Model: AI-P1	Date: 13-Mar-08	No.: RG179001c
--------------	-----------------	----------------

Subject: Firmware Release Note: Network DocBox		Prepared by: K.Hamada	
From: 1st Overseas Tech Support Sec., 1st PQM Dept.			
Classification:	<input type="checkbox"/> Troubleshooting	<input type="checkbox"/> Part information	<input type="checkbox"/> Action required
	<input type="checkbox"/> Mechanical	<input type="checkbox"/> Electrical	<input type="checkbox"/> Service manual revision
	<input type="checkbox"/> Paper path	<input type="checkbox"/> Transmit/receive	<input type="checkbox"/> Retrofit information
	<input checked="" type="checkbox"/> Other (      )

Model: AL-P1		Date: 17-Aug-09	No.: RG179012
Modified Article: Filter		Prepared by: K. Hamada	
From: 2nd Tech. Support Sec. Service Support Dept.			
Reason for Modification:	<input type="checkbox"/> Parts catalog correction	<input type="checkbox"/> Vendor change	<input type="checkbox"/> Other
	<input type="checkbox"/> To facilitate assembly	<input checked="" type="checkbox"/> To improve reliability	<input type="checkbox"/> To meet standards ( )
	<input type="checkbox"/> Part standardization	<input type="checkbox"/> Product Safety

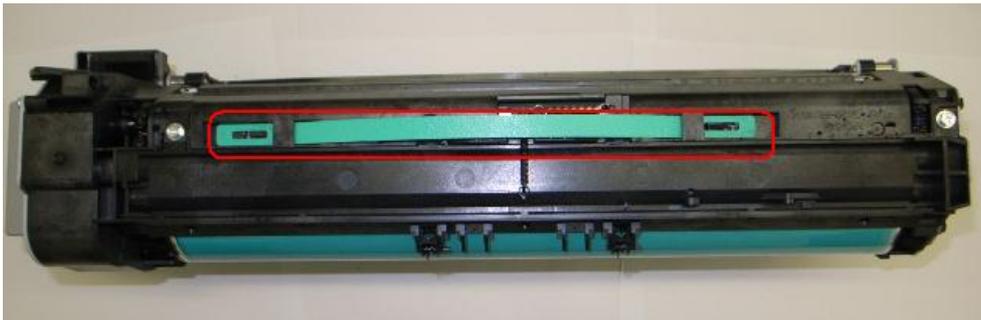
The toner was modified to minimize a decrease in chargeability under the conditions listed above.

**Note:** The modified toner has a lot number that ends in **suffix A**.

Old part number	New part number	Description	Q'ty	Int	Page	Index	Note
	D0093264	Cam: handle	0-1	-	25	18

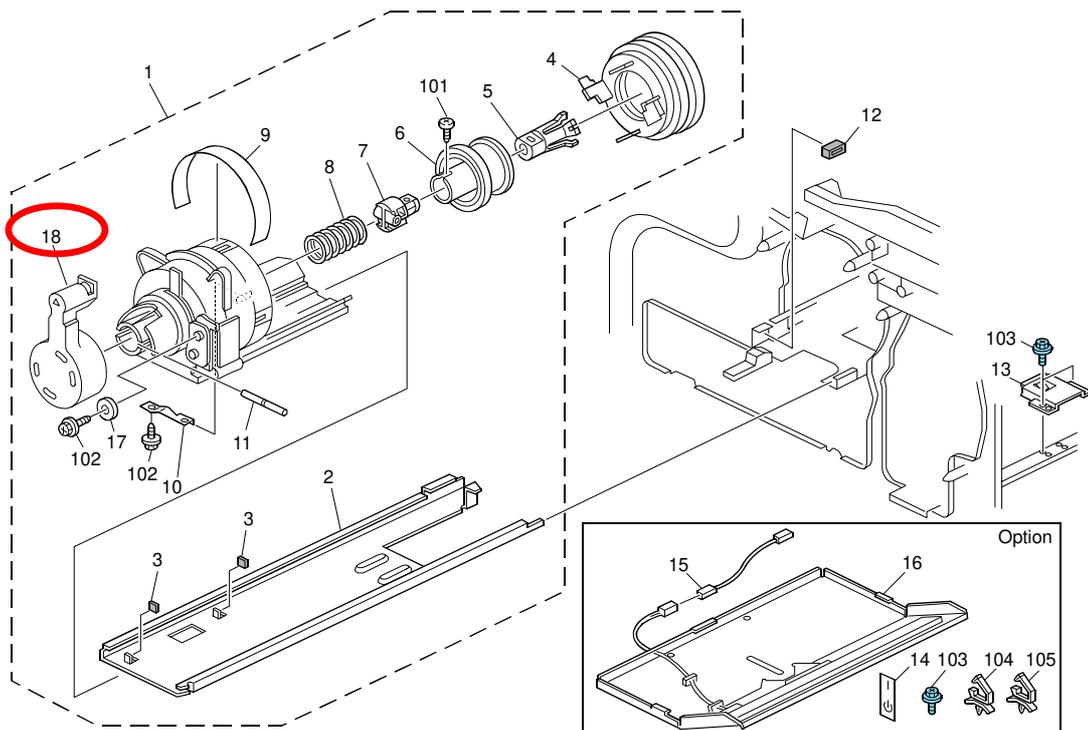
**Change/ Reason:** This part is added due to a field request.

Old part number	New part number	Description	Q'ty	Int	Page	Index	Note
-	14076362	EEPROM:BR24L64-W	0-1	-	69	114	
<b><i>G1795135</i></b>	<b><i>G1795136</i></b>	<b><i>PCB:BCU:AL-P1:ASS'Y</i></b>	<b><i>1-1</i></b>	<b><i>O/O</i></b>	<b><i>69</i></b> <b><i>93</i></b>	<b><i>6</i></b> <b><i>*</i></b>

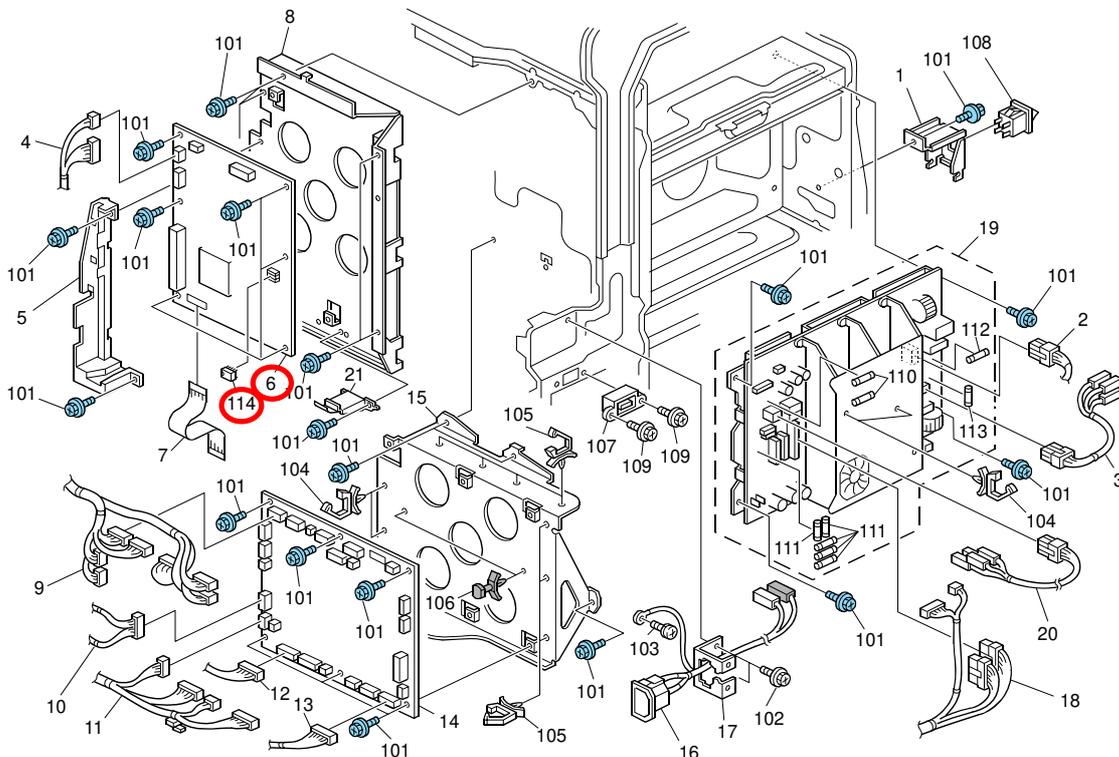
- 1) ***The EEPROM is no longer included with the BCU.***
- 2) ***Instead, the EEPROM was added as an individual service part.***
- 3) Index #114 (:EEPROM: BR24L64-W) was added to the illustration.

11.PCDU 2 (G179)

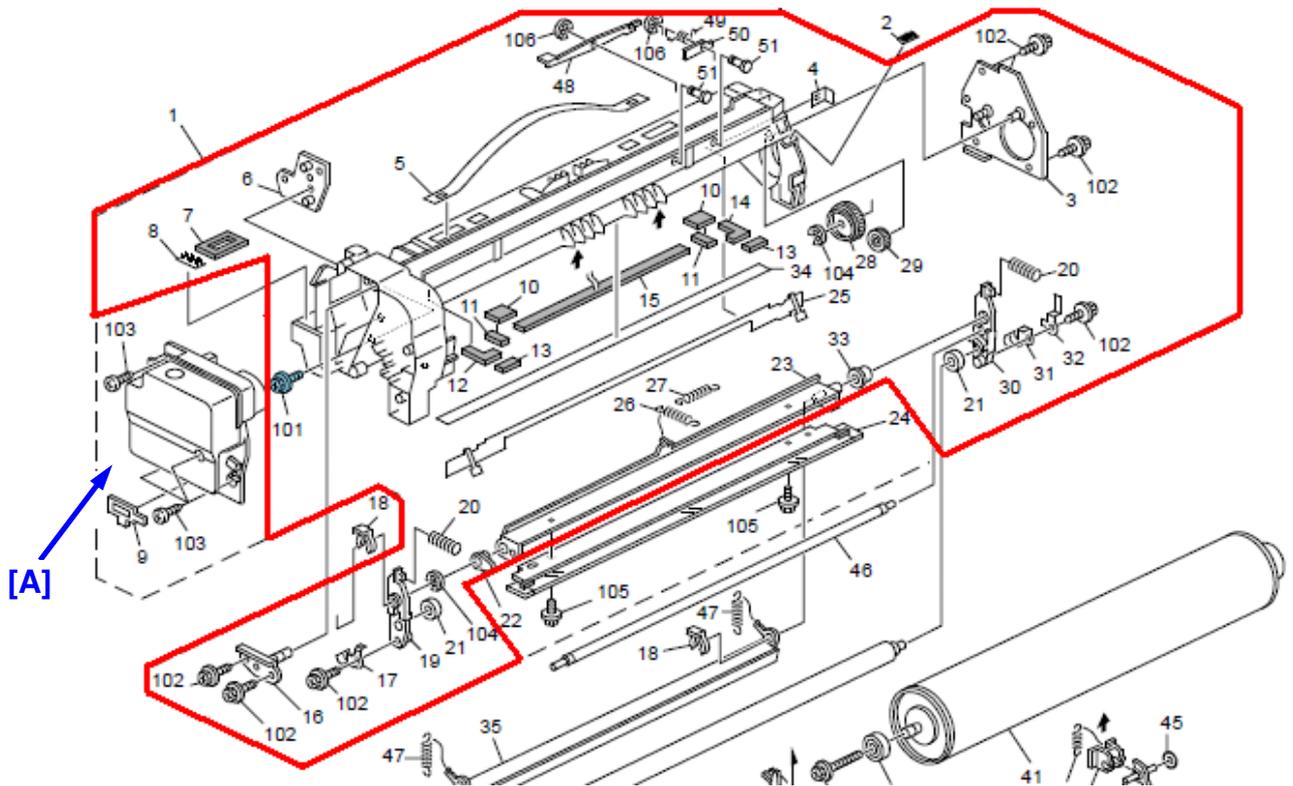
**Change/Reason:** The illustration shown below was corrected.

- The area enclosed by the red box is the correct outline for P/N G1792211 (index #1).
- The cover marked "[A]" below is included in P/N G1792200 (PCU).
- ***Cleaning Blade (p/n:D0092351) is not included in Frame:PCU:Upper:Ass'y (p/N:G1792211)***

Old part number	New part number	Description	Q'ty	Int	Page	Index	Note
-D0092617	D1292617	GUIDEPLATE:REGISTRATION:UPPER	0-1	X/O	14	3

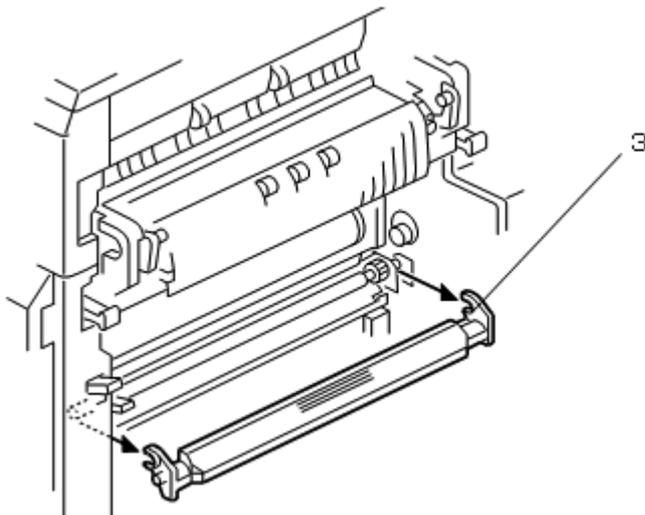
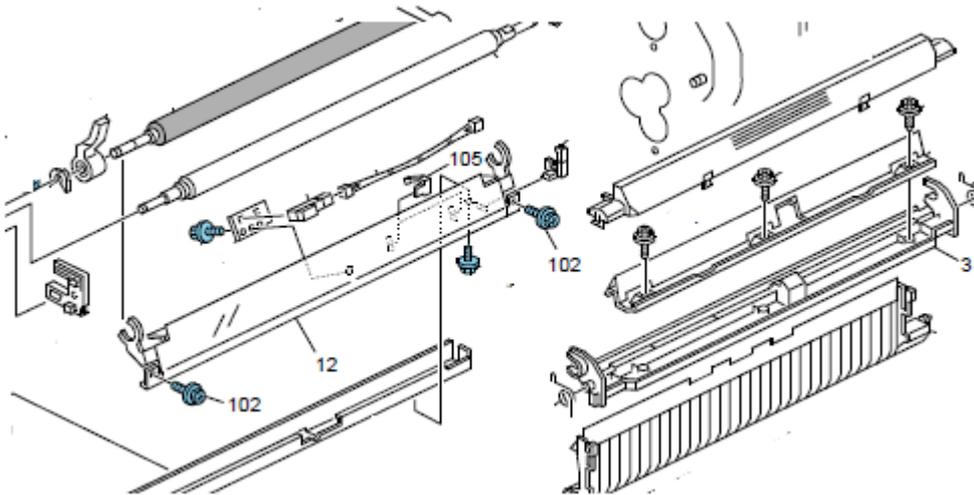
**Change:** The method for attaching the COVER-PAPER DUST REMOVAL & GUIDPLATE:REGISTRATION:UPPER was changed. **See details below.**

**Reason:** To further strengthen the integrity of the connection.

- Co-fastening ribs were added to the guide plate (index #3 below).
- This guide plate and registration lower guide plate (index #12) are fastened to each other using a screw (after the shaft is attached).
- The length of this fastening screw was increased from 6mm to 8mm (index #102)

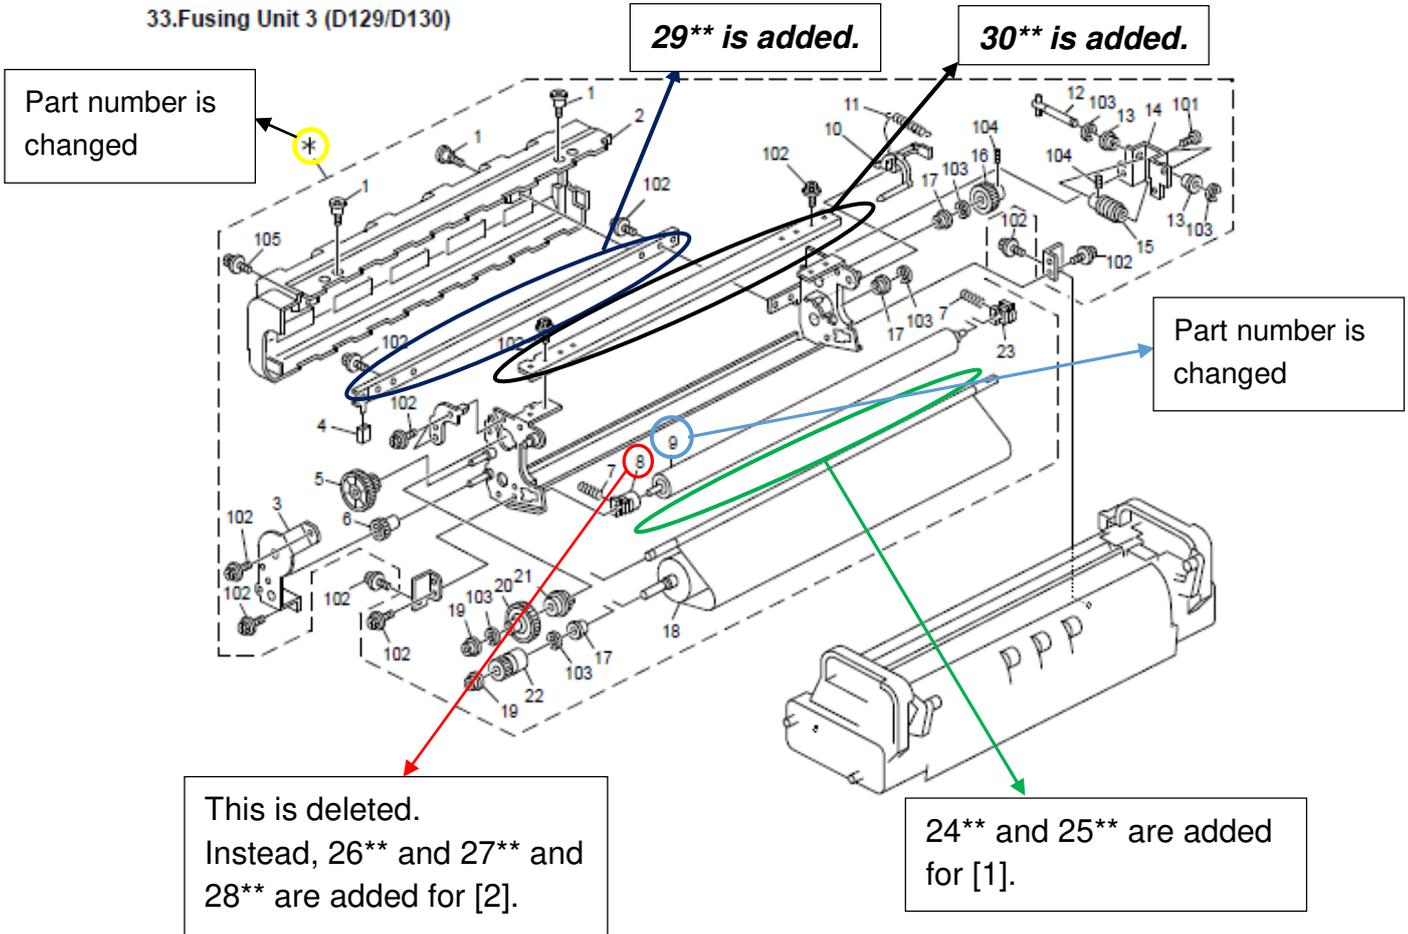
**Change/Reason:** To prevent the cleaning web coming loose, the following parts are changed and newly added to the fusing unit.

[2] Changed the one-way clutch method to ratchet method on the holder roller.

**For details of [1], please refer to the following pictures.**

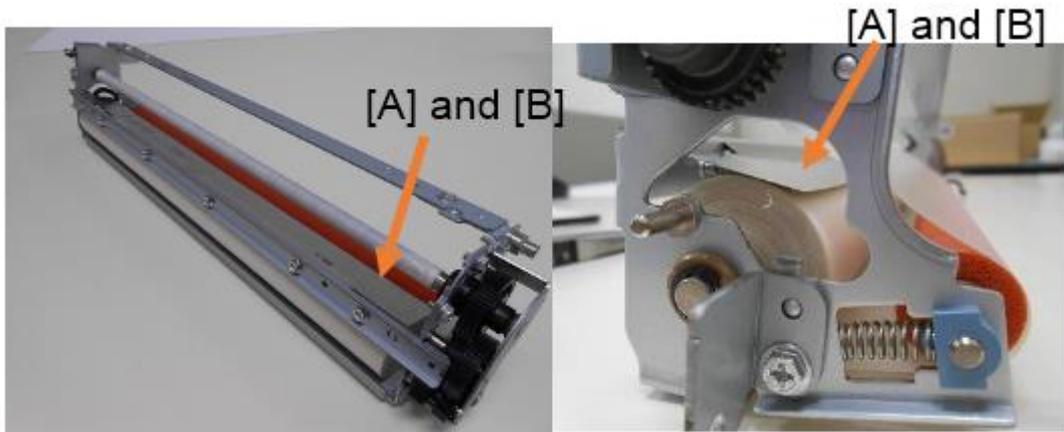
[A] and [B] are the variable brake.

**For details of [2], please refer to the following picture.**

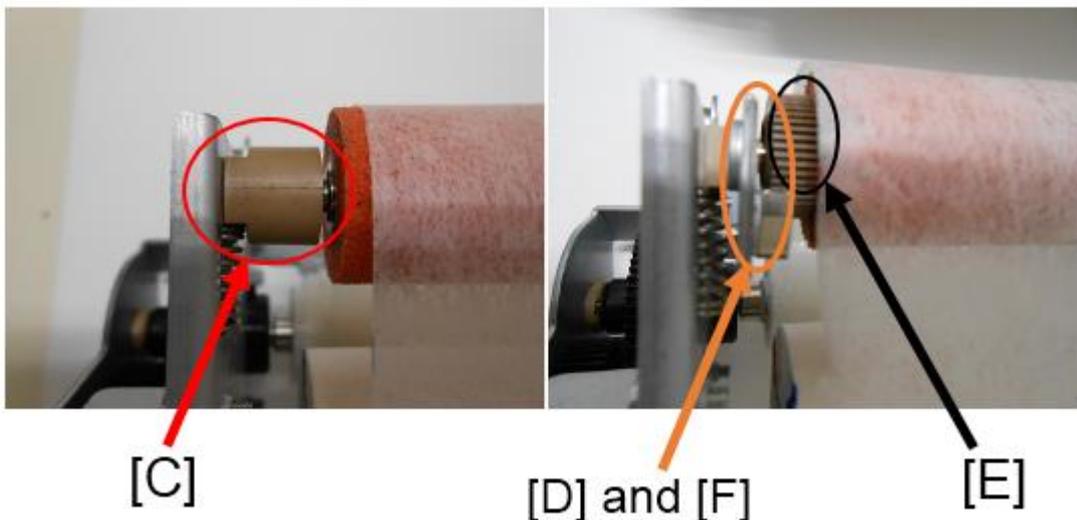
One-way clutch method was used before. Ratchet method is used after.

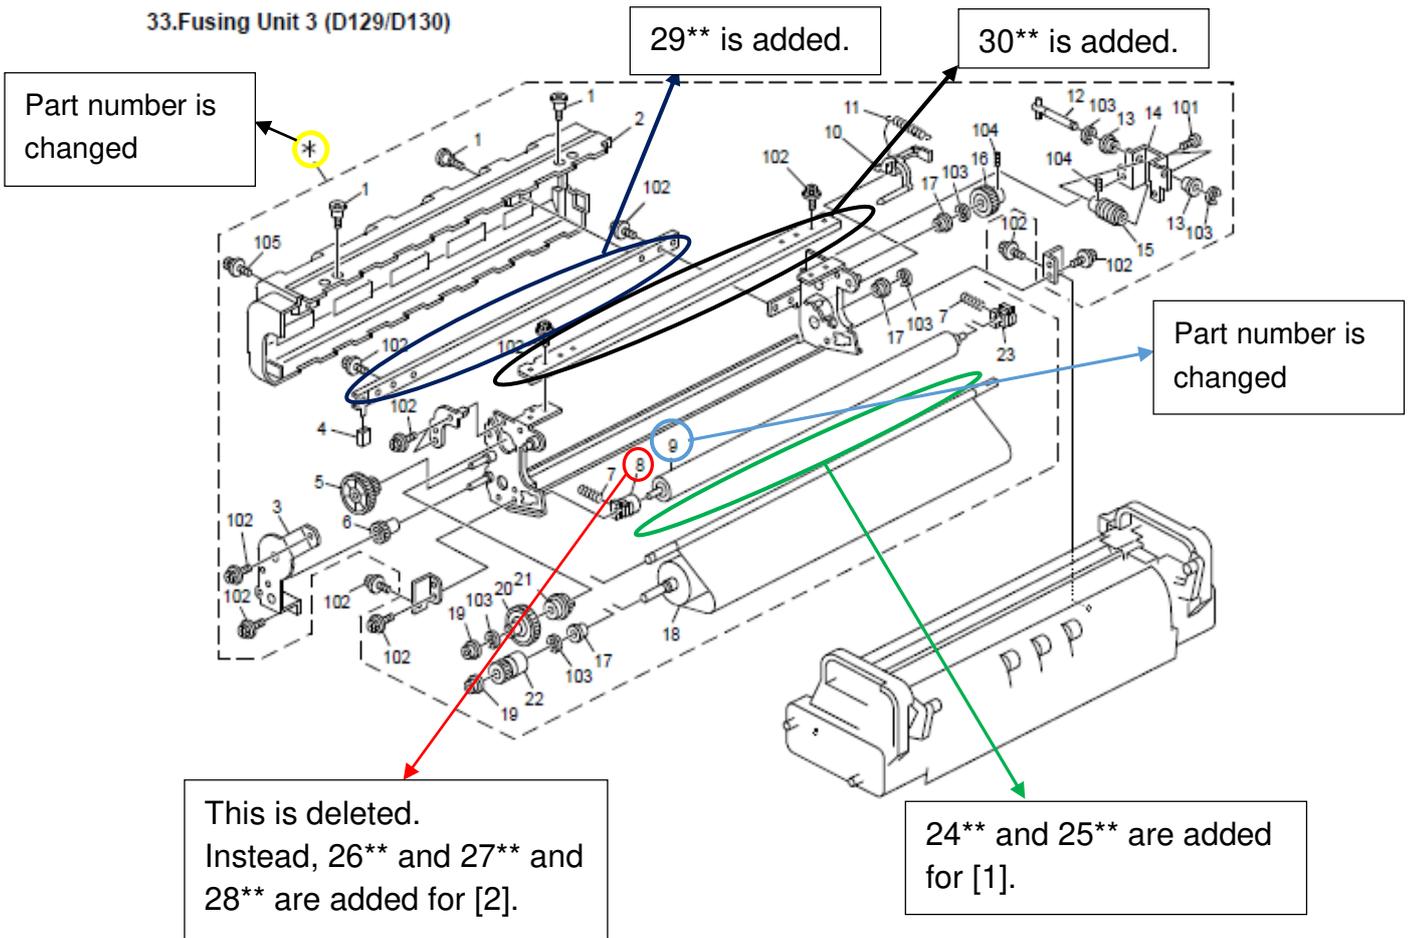
To prevent the cleaning web from coming loose, the following parts are changed or newly added to the fusing unit.

[1] The addition of a variable brake to the cleaning web.

[2] Changed the one-way clutch method on the holder roller to ratchet method.

**[1] Variable brake**

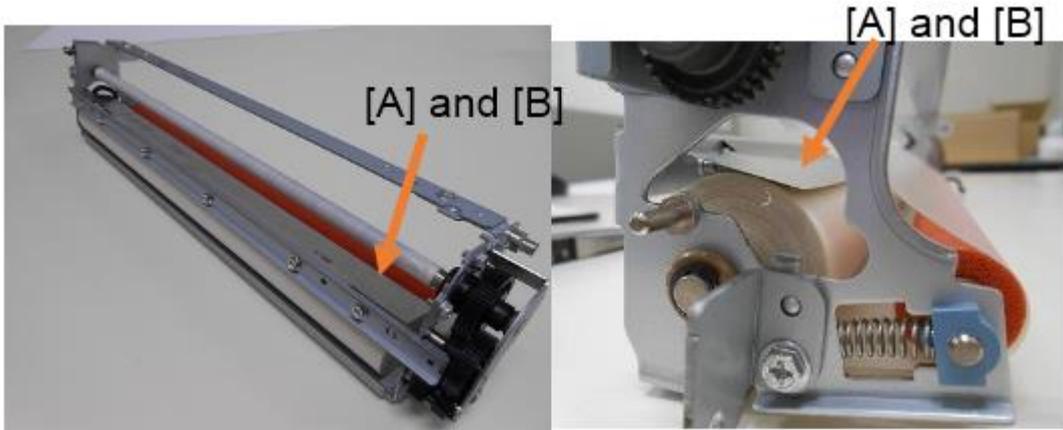
[A] and [B] are the variable brake.

**[2]: One way clutch method**

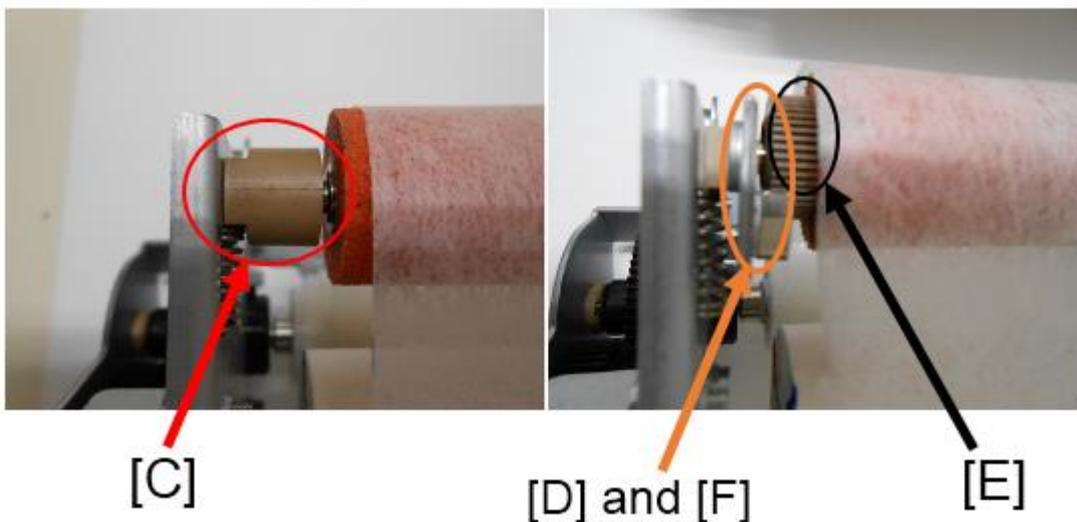
One-way clutch method is before.  
One-way clutch method

Ratchet method is after.  
Ratchet method

Please install a new cleaning unit (p/n: D1294304) when a cleaning web issue occurs, because individual parts are not compatible due to modification of a frame on the fusing unit. After that, individual parts can be replaced.
